Access Compliance Report

Public Rights-of-Way

Intersection ID: 16670	Main Street: BEVERLY_DR	Cross Street: PROVIDENCE_RD	Location: NW
ADA ID: 23A7BC587267	Ramp Type: Perp	Initial Pass/Fail: Fail	Overall Compliance: No
		Severity Score: 8.75

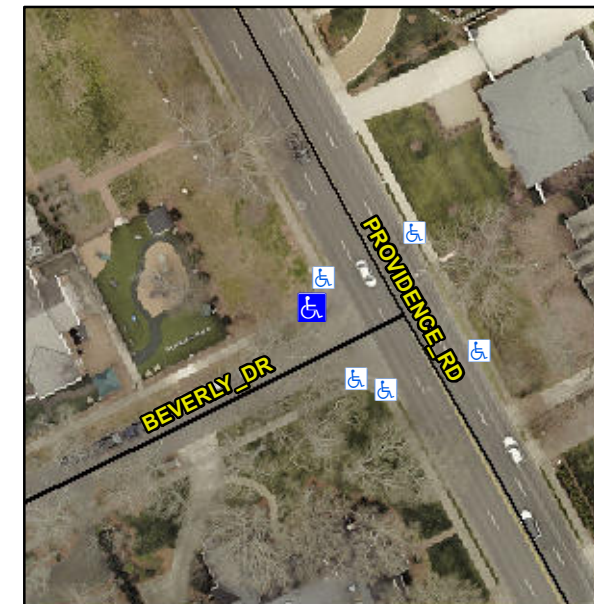
Not Found, R304.5.1

Compliance	Description	Data	Compliance	Description	Data
N/A	Ramp Length (in)	60.0	Yes	Ramp Slope (%)	5.5
No	Ramp Width (in)	46.0	Yes	Ramp XSlope (%)	0.1
N/A	Flare Type LT	N/A	N/A	Flare Type RT	N/A
N/A	Flare Slope LT (%)	N/A	N/A	Flare Slope RT (%)	N/A
N/A	Flare Traversable LT?	N/A	N/A	Flare Traversable RT?	N/A
N/A	Landing Length (in)	N/A	N/A	DWS Provided?	N/A
N/A	Landing Width (in)	N/A	N/A	DWS Contrast?	N/A
N/A	Landing Slope (%)	N/A	N/A	DWS Length (in)	N/A
N/A	Landing X Slope (%)	N/A	N/A	DWS Full Width?	N/A
N/A	Landing Curb? (Y/N)	N/A	N/A	DWS Offset (in)	N/A
N/A	Shared Landing?	N/A			
N/A	Gutter Ponding?	N/A	N/A	Gutter Slope (%)	N/A
N/A	Gutter Lip Ht (in)	N/A	N/A	Gutter X Slope (%)	N/A
N/A	Painted X Walk1?	No	N/A	Painted X Walk2?	N/A
	X Walk 1 Direction	To SE		X Walk 2 Direction	N/A
N/A	X Walk 1 Width (in)	N/A	N/A	X Walk 2 Width (in)	N/A
	X Walk 1 Slope (%)	2.8		X Walk 2 Slope (%)	N/A
	X Walk 1 X Slope (%)	0.7		X Walk 2 X Slope (%)	N/A

Remove & Replace Entire Ramp.
